Evaluation of Air Pollution Regulatory Strategies for Gasoline Marketing Industry —

Response to Public Comments

EPA 450/3-84-012c

U.S. ENVIRONMENTAL PROTECTION AGENCY
Office of Air and Radiation
Washington DC 20460
July 1987

Figure 2-1. Onboard System Mechanical Seal

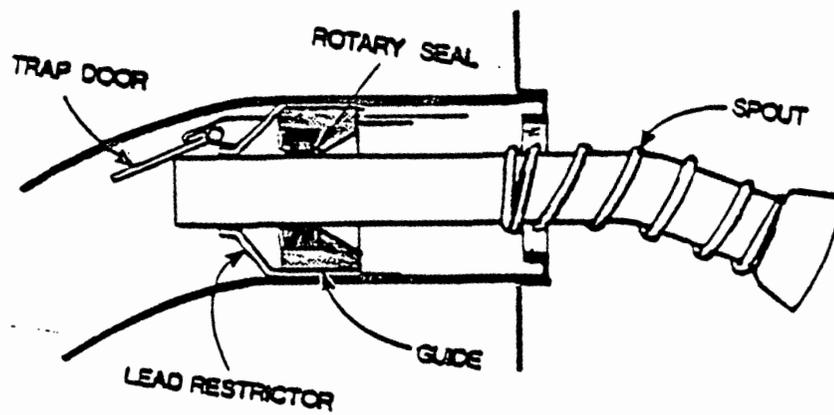
A number of commenters voiced their doubts about the durability of mechanical seals. Although the API demonstration vehicles were driven up to 65,000 miles, none was driven the light-duty vehicle (LDV) average lifetime of 100,000 miles, and a number of commenters questioned the ability of the seal to retain its integrity over the life of the vehicle in a wide range of environmental conditions.

Many commenters also stated that a pressure relief device would be needed if the mechanical type fillpipe seal were used. This would be needed to prevent damage to the fuel tank and other system components if the automatic nozzle shutoff mechanism failed or if the vapor line between the fuel tank and an onboard refueling canister became blocked. In these situations, the fuel tank could come under excessive pressure as more fuel was dispensed into the tank. Also, if the fuel tank were slightly overpressured as described above, a pressure relief device would also help to reduce fuel spit-back which could occur when the nozzle was removed from the fillpipe. Although an adequate pressure relief device could be designed without an unreasonable amount of effort, the commenters argued that such a device would add an additional level of cost and complexity to the system.

Comment: As discussed above, a number of commenters expressed the belief that the mechanical fillneck seal would not be durable enough to last the full life of an LDV or LDT (I-H-2, I-H-11, I-H-99, I-H-100, I-H-101, I-H-116, I-H-120, I-H-127). This conclusion was based on the fact that no vehicle had been operated with onboard controls past 65,000 miles. It was also based on concerns that the seals had not been exposed to the variety of environmental extremes that might be encountered in use. One commenter raised the question of whether an onboard system with a mechanical seal would comply with existing regulations concerning fillneck access. Several others felt that onboard control systems would be subject to tampering (see Section 2.2.5).

Response: In the onboard control system described above, a liquid seal is used to prevent vapors from leaving the fuel tank via the fillneck. As was discussed previously, liquid seal designs such as this avoid many of the potential problems associated with mechanical seals. All problems of durability are eliminated because a new seal is formed with each refueling. The comments on the ability of the seal to function in environmental extremes are also addressed by the use of the liquid seal, since extremely cold or hot weather would have no effect on the functioning of the liquid traps.

The liquid type seals also avoid concerns about tampering, because the modifications to provide the liquid seal would be out of the nozzle operator's sight. From the nozzle operator's perspective, the controlled refueling event would appear identical to the current uncontrolled event.

Figure 2-9

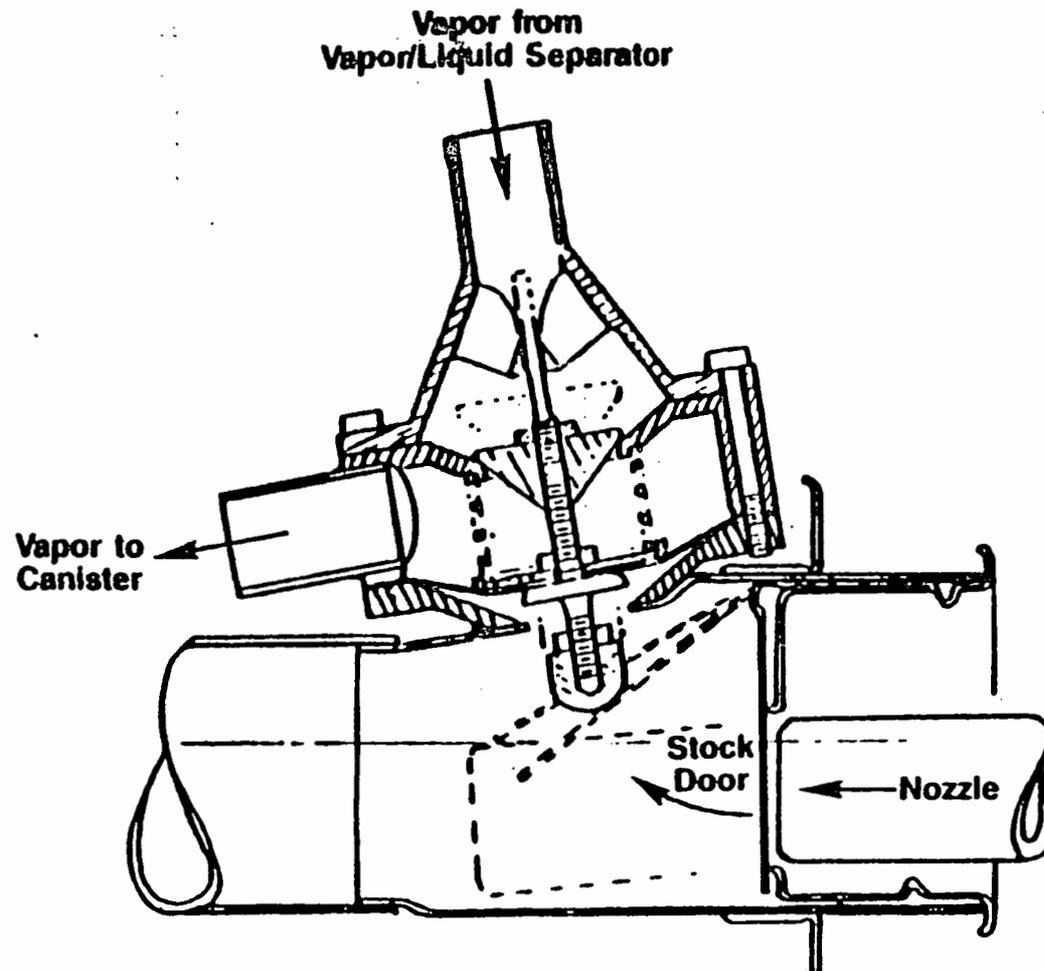
Comment: The commenters on the safety of onboard control systems addressed three main issues: (1) gasoline spillage and the need for a pressure relief mechanism, (2) fuel system integrity during accidents or vehicle rollover, and (3) potential hazards related to the carbon canister. The comments related to these topics are summarized below.

A second major topic of comment was the integrity of the fuel system during accidents or vehicle rollover. Commenters noted that onboard systems would have to be designed to accommodate the high vapor flow rates associated with refueling, and this would involve larger vapor lines and associated orifices. Some changes would therefore have to be made to ensure that Federal fuel tank integrity standards (FMVSS 301) could be met. Some commenters claimed that this would require more than a simple enlargement of existing rollover valves (I-H-2, I-H-53, I-H-90, I-H-100, I-H-101, I-H-114, I-H-118, I-H-127). Also, one commenter noted that the connections needed to link the additional onboard vapor lines and valve(s) from the fuel tank to the carbon canister would create more chance for a loss of fuel system integrity during a vehicle accident.

Adjacent to the fill limiter in the onboard system discussed above, is the refueling vent line closure valve. In the open position, this device provides a large orifice (which can accommodate the high vapor flow rates associated with refueling) and could also be designed to provide a limiting orifice when closed (see Figure 2-7). The valve is open whenever the fuel cap is not in place on the fillneck and is closed at all other times. When closed, the valve would serve to limit the loss of gasoline from the fuel tank during a vehicle rollover. This is the problem addressed by FMVSS 301, which requires a vehicle to restrict fuel leakage to less than one ounce per minute when rolled on either side or upside down following a front, rear, or side collision.

The mechanical approach to the refueling vent valve demonstrated by API also addressed the need for vent line closure in the event of vehicle rollover (I-H-158). This kind of valve (Figure 2-9) is closed at all times except during refueling, and should therefore prevent the escape of fuel in a rollover incident. Only when the nozzle is inserted into the fillneck does the valve move to the open position, allowing vapor to leave the tank. A mechanical valve located at the vehicle/fillneck interface does present one safety concern that doesn't apply to the solenoid type valve. Because the valve is located near the exterior shell of the vehicle it could be susceptible to damage if struck in a collision. Although this is an issue that would have to be addressed by a manufacturer, it seems that the vent valve would be no more susceptible than the fillpipe or gas cap. This valve would have to be
